Customer Notification

B-CN-314-EN REV A

SUBJECT: TT Series Cover Screw Torque

Figure 1 – Cover Screw Torque

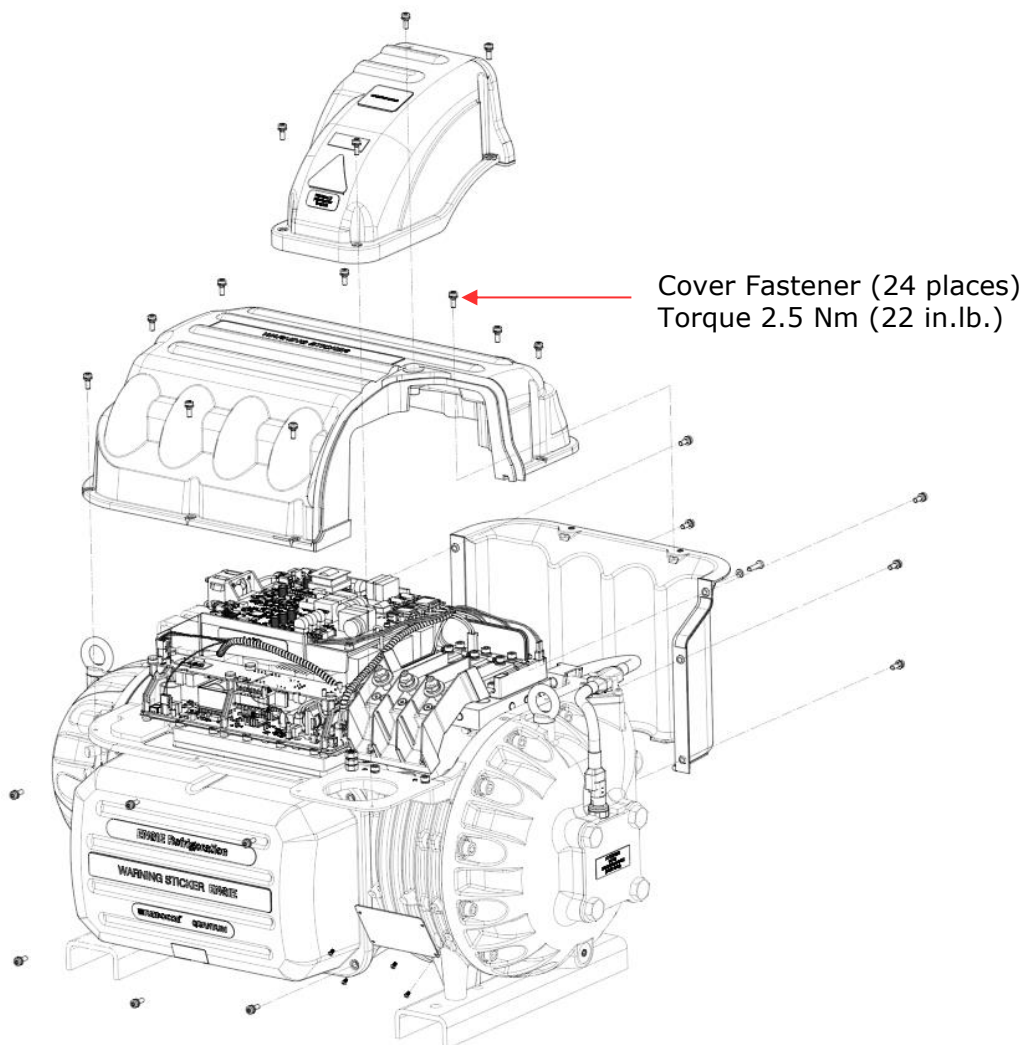
This is to inform Danfoss customers that we have updated the torque specification for our TT Series Compressor cover fasteners. Our Service Manual previously stated the torque for the cover screws was 1.5 Nm. The new torque specification is now 2.5 Nm (22 in.lb.).

We have updated our TT Series Cover fastener torque specifications to 2.5 Nm (22 in.lb.). This updated torque specification applies to all four (4) covers.

When installing any TT Series Compressor cover, torque the fasteners to 2.5 Nm (22 in.lb.).
